**TECHNICAL BULLETIN**  
**Bell Helicopter** **TEXTRON**

No. 407-03-53

**MODEL AFFECTED:** 407

**SUBJECT:** AFT FIREWALL REINFORCEMENT

Figure 1. Aft firewall modification (sheet 1 of 5)

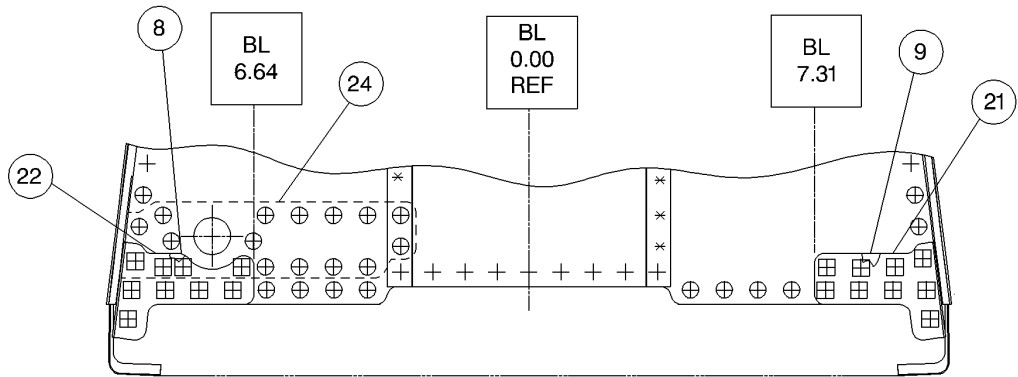
1. Removing rivets and trimming.
  - a. Refer to figure 1 sheet 1. Use a #40 drill and remove qty 14 rivets horizontally attaching web (3) to support (16).

- b. Remove qty 5 rivets on each side vertically attaching web (3) to channels (6,11,14, and15).
  - c. Refer to view X-X. Remove rivets securing receptacles (13) to channel (14 and 15). Keep receptacles (13) for reuse. Remove qty (2) remaining rivets attaching existing doubler (17) to channel (14 and 15). Discard both doublers (17).

- d. Partially unglue gasket and remove 2 rivets at bottom of channel (6 and 11).
  - e. From forward side of firewall, lift web (3) and trim each lower corner to eliminate the joggle area as shown in Detail A.

- f. Trim top portion of existing striker (19) flush with top of side skin as shown in View X-X.
2. Refer to figure 1, sheet 1. Replacement of channel 206-064-902-035 / -036 (14 and 15). If existing channels (14 and 15) are damaged or cracked, proceed as follows. If channels are serviceable, proceed to step 3.

**Figure 1. Aft firewall modification (sheet 2)**

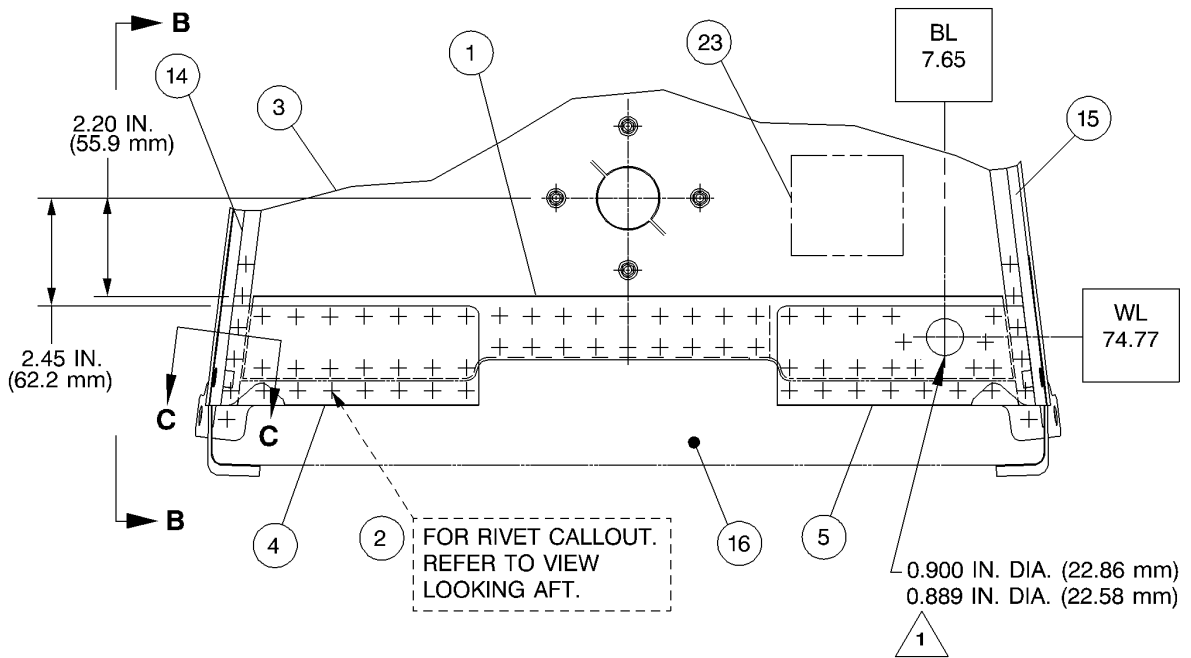
- a. Refer to figure 1 sheet 2. Position L/H stiffener (4) on the aft face of the web (3). Ensure it is nesting in existing channel (14) and position top edge of stiffener (4) at 2.45 inch from tail rotor driveshaft centerline.
- b. Use a #40 drill and backdrill any 2 holes in horizontal row from web (3) and support (16). Backdrill all vertical holes common to channels (11 and 14) through stiffener (4). Secure with clecos.

- c. Position R/H stiffener (5) on the aft face of the web (3). Ensure it is nesting in existing channel (15) and position top edge of stiffener (5) at 2.45 inch (62.2 mm) from tail rotor driveshaft centerline.

- f. Insert doubler (1) between web (3) and stiffeners (4 and 5). Position top edge of doubler (1) at 2.20 inch (55.9 mm) from tail rotor driveshaft centerline as shown in figure 1 sheet 2.

1. Removing rivets and trimming.
  - a. Refer to figure 1 sheet 2. Use a # 40 drill and remove qty 18 rivets attaching existing doublers (21 and 22) and fillers (8 and 9) as shown in view D. Discard doublers (21 and 22) and keep fillers (8 and 9) for reuse.
  - b. Use a #40 drill and remove qty 25 remaining rivets attaching web (3) to channels (6,11,14, and15) and doubler (24). Discard doubler 24.
  - c. Refer to View X-X. Remove rivets securing receptacles (13) to channel (14 and 15). Keep receptacles (13) for reuse. Remove qty (2) remaining rivets attaching existing doubler (17) to channel (14 and 15). Discard both doublers (17).
  - d. Partially unglue gasket and remove 2 rivets at bottom of channel (6 and 11).

- f. Insert doubler (1) between web (3) and stiffeners (4 and 5). Position top edge of doubler (1) at 2.20 inch (55.9 mm) from tail rotor driveshaft centerline as shown in figure 1 sheet 2.
  - g. Refer figure 1 sheet 2. At WL 74.77 and RBL 7.65 drill hole 0.889 /0.990 thru stiffener (5)
  - h. Do not drill all the rivet at this time.
3. Refer to figure 1 sheet 3. Locate supports 206-064-902-163 / -165 (7 and 10) and filler 206-064-902-167 (12) as follows:

Figure 1. Aft firewall modification (sheet 3)

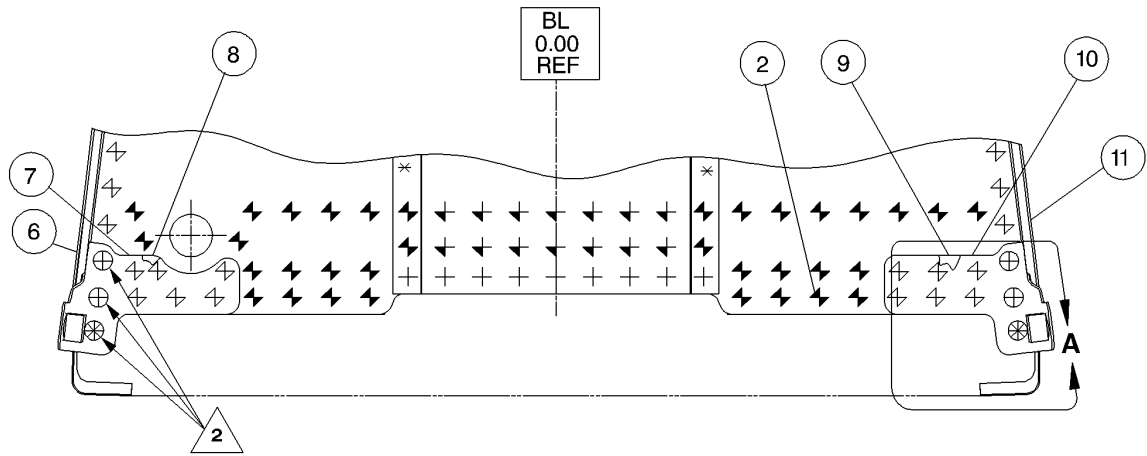
- g. Do not drill all the holes at this time.
4. Refer to figure 1 sheet 3. Locate supports 206-064-902-163 / -165 (7 and 10) and fillers 206-064-902-167 / -173 / -175 (12, 9 and 8) as follows:

- a. Trim forward flange of existing channels (6 and 11) as shown in Detail A.
- b. Position filler (12) in channels (6 and 11) flush with bottom edge of channels and temporarily hold in place with masking tape or equivalent.

- c. Place filler (8) on support (7) and filler (9) on support (10). Position supports (7 and 10) and fillers (8, 9) on forward side of firewall and against fillers (12). Ensure to maintain a minimum gap of 0.050 inch (1.3 mm) in relation with top side skin as shown in view B-B.

- d. Using #40 drill, drill the complete horizontal top and middle row of rivets through all parts. If a rivet hole is interfering with radius of supports (7 and 10), locally fabricate a radius block made of CRES 301 0.090 inch (2.29 mm) thick.

- g. Reinstall all parts together in wet firewall sealant (C-353) with cleco and allow to cure for 24 hours.
- h. Install all rivets as shown in figure 1.

Figure 1. Aft firewall modification (sheet 4)

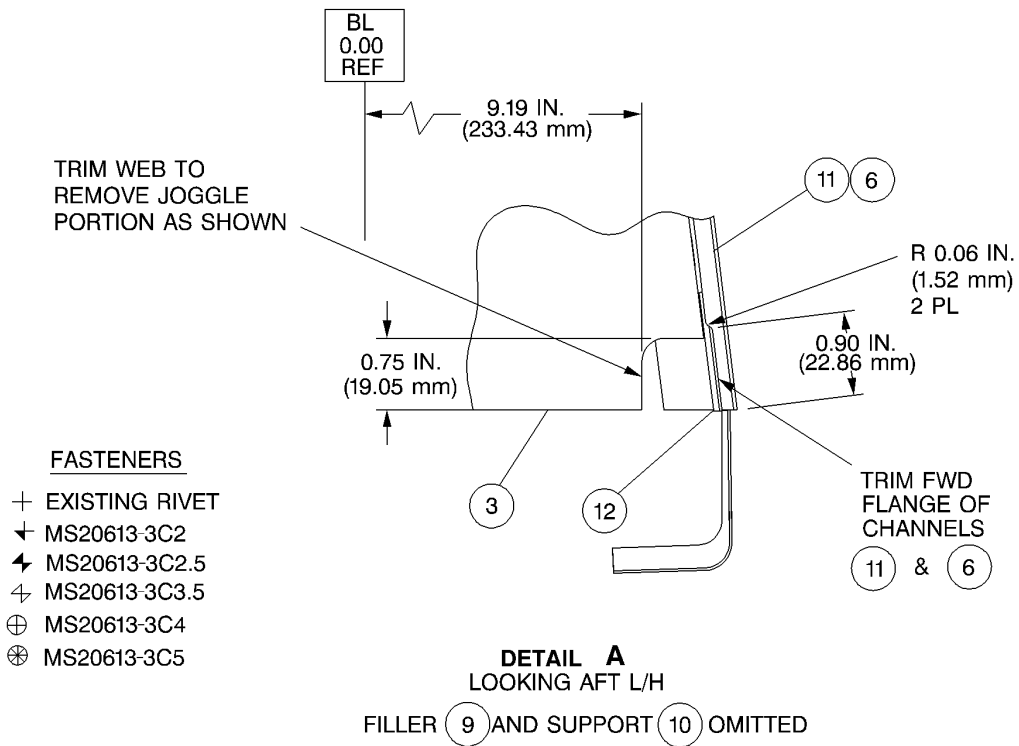
- e. Refer to figure 1, sheet 4. Using #40 drill bit, drill 4 rivet holes for receptacles (13) and 4 existing rivet holes thru channels (14 and 15) and stiffeners (4 and 5). Dimple 8 holes in stiffeners (4 and 5).

- e. Refer to figure 1 sheet 4. Using #40 bit, drill 4 rivet holes for receptacles (13) and 4 existing holes thru channels (14 and 15) and stiffeners (4 and 5). Dimple 8 holes in stiffeners (4 and 5).

Do not drill if aircraft is not modified with the oil cooler support strut and oil cooler line relocation. Rivet pattern to be followed in prevision of further modification. If aircraft has been modified with oil cooler strut (same configuration as aircraft 53560 and Sub), transfer this hole from web (3) to doubler (1) and stiffener (5).

If rivets holes are in radius of supports (7 and 10), it is permissible to install a radius block made of CRES 0.090 inch thick. Install in wet sealant C-353.

Figure 2. Engine door and aft fairing modification (sheet 1 of 5)

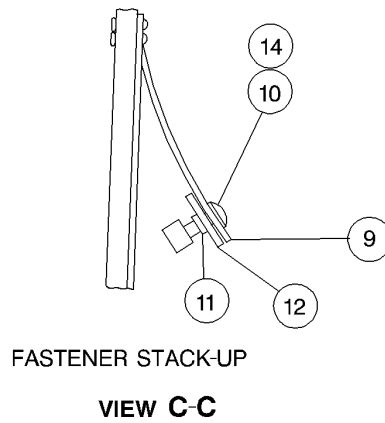
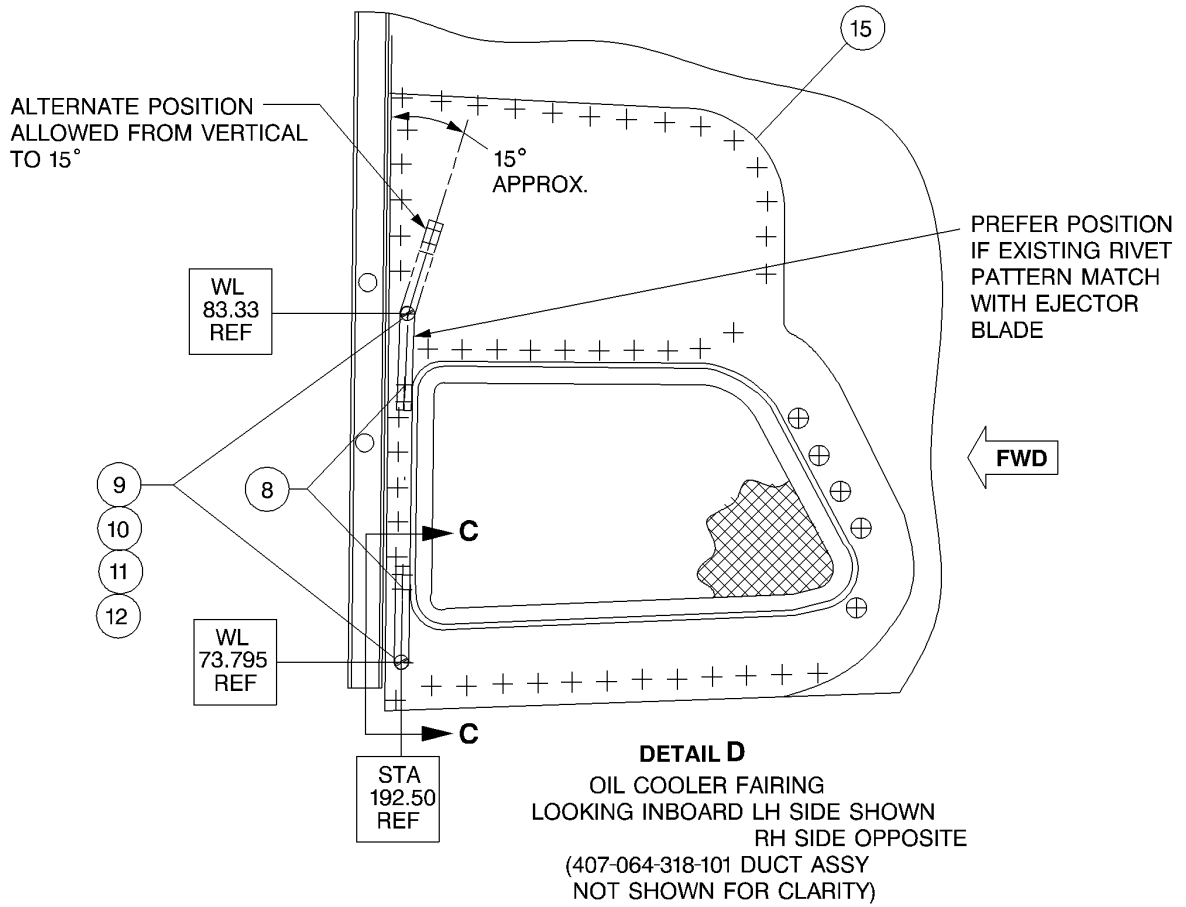
1. Figure 2 sheet 1. Modify engine doors as follows:
- a. Use a #30 drill and remove 4 rivets (7) attaching doubler (3) to engine door (1). If installed, remove nutplate (5) and discard. Using a sharp putty knife or equivalent, separate existing doubler (3) from door (1) and discard. Clean residual sealant from door (1).
  - b. Fabricate a new doubler (4) to dimension as shown in detail B using 0.025 inch (0.64 mm) thick material MIL-T-9046, 12 X 12. Edge of doubler to match with the door contour.

- c. Transfer 3 holes from door to doubler (4). Drill hole size 0.203 / 0.208 inch (5.16/5.28 mm). If a standard nutplate was installed, drill holes to install a one way nutplate (5) with rivet pattern facing forward.

- d. Remove primer and paint only by sanding. Deburr and clean all parts with acetone C-316.
  - e. Install new doubler (4) in sealant C-559 with rivets (7) and nutplate rivets (5) while wet. Clamp between a piece of wood or masonite and let cure for 24 hours allowing for proper bonding.

- f. Refer to figure 2, detail A. Temporarily install engine cowling and doors on aircraft and close door. Use a # 40 drill thru engine door (1) and match with support (figure 1 View B-B, 7 and 10) to locate center of receptacle (20).

- g. Figure 2, open hole in engine door (1) to .218/.226 inch (5.54/5.74 mm). Deburr and clean with acetone C-316. Apply sealant C-559 on edge of hole. Bond washer 407-064-806-147 on outboard face of door (1) with adhesive C-559, and let cure. Install wing stud, and grommet (6).

Figure 2. Engine door and aft fairing modification (sheet 3)

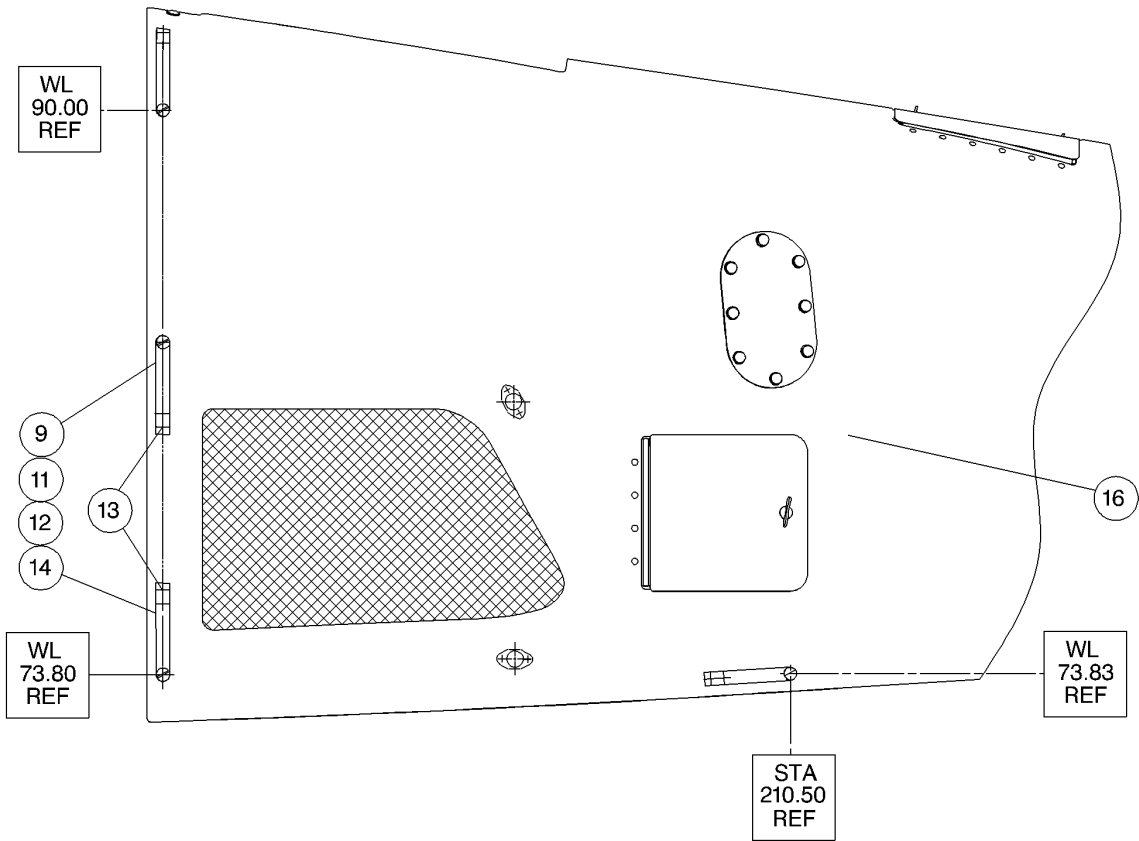
- e. Refinish door as required.
2. Refer to Figure 2 Detail F. Modify oil cooler fairing as follows:
    - a. Locate lower ejector blade (9) with rivet pattern pointing up. Use a #40 drill and open 2 holes in fairing to match lower ejector blade (9). Install rivets (13) thru ejector and fairing in wet sealant C-559.
    - b. Locate upper ejector blade (9) with rivet pattern pointing down. Use a #40 drill and open 2 holes in fairing to match upper ejector blade (9). Install rivets (13) thru ejector and fairing in wet sealant C-559.
    - c. Install stud (14) in ejector blade (9), slide washer (12) and lock in place with grommet (11) as shown in View C-C at upper and lower ejector blades.
    - d. Refinish as required.
    - e. Proceed to Part VI.

Figure 3. Modification of oil cooler inlet duct (sheet 1 of 2)

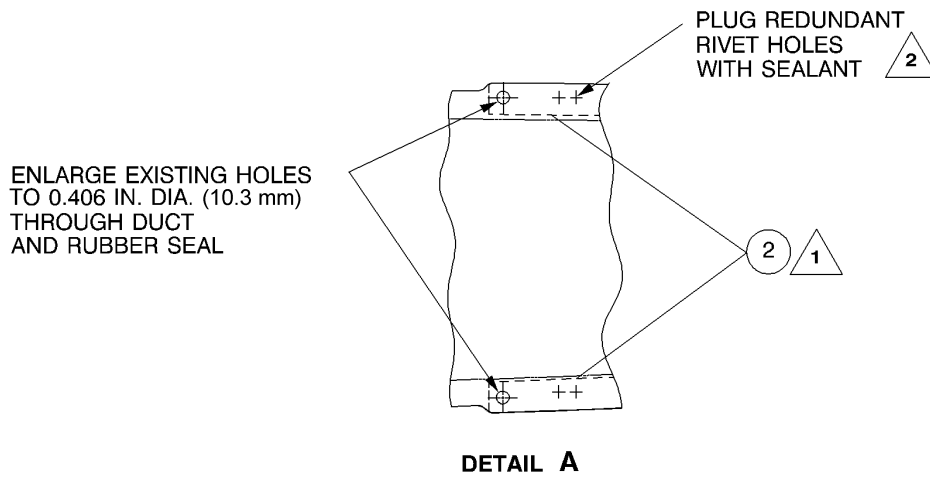
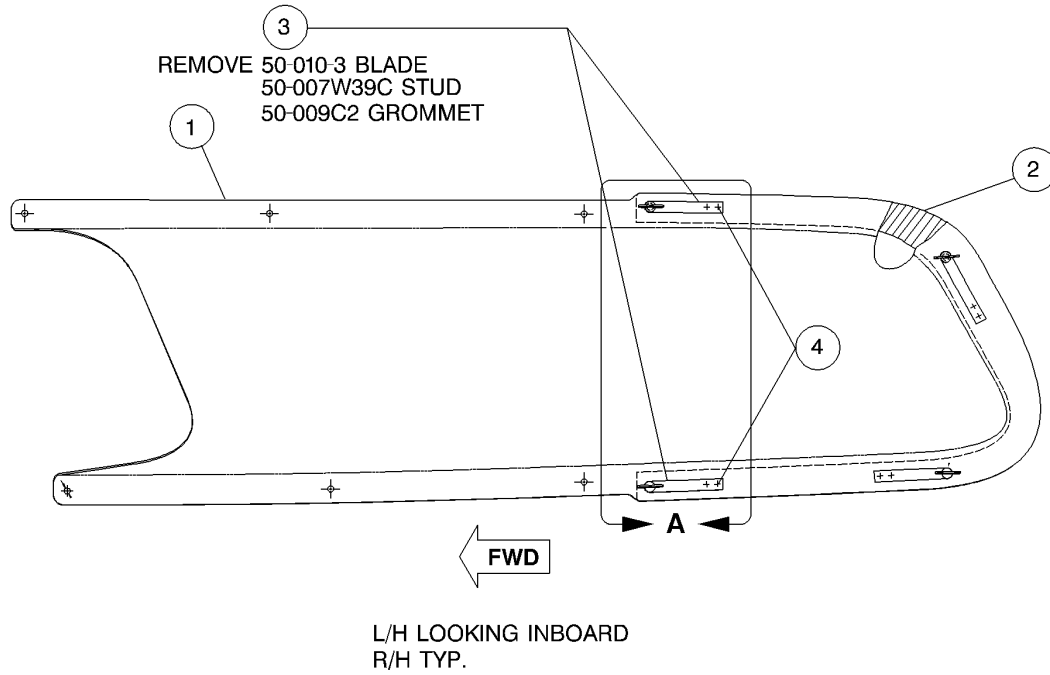
1. Refer to Figure 3. Modify oil cooler inlet duct assy as follows:
  - a. Remove 2 existing ejector blades (3) on each inlet duct assy by drilling rivets (4).
  - b. Enlarge hole to 0.406 inch (10.3 mm) thru duct (1) and seal (2) to clear stud (figure 2, item 10 or 14) head. Seal edge with sealant C-392. See Note 2.
  - c. Fill open rivet holes in duct (1) with sealant C-392. See note 2.
  - d. Let cure for 24 hours.
  - e. Refinish as required.
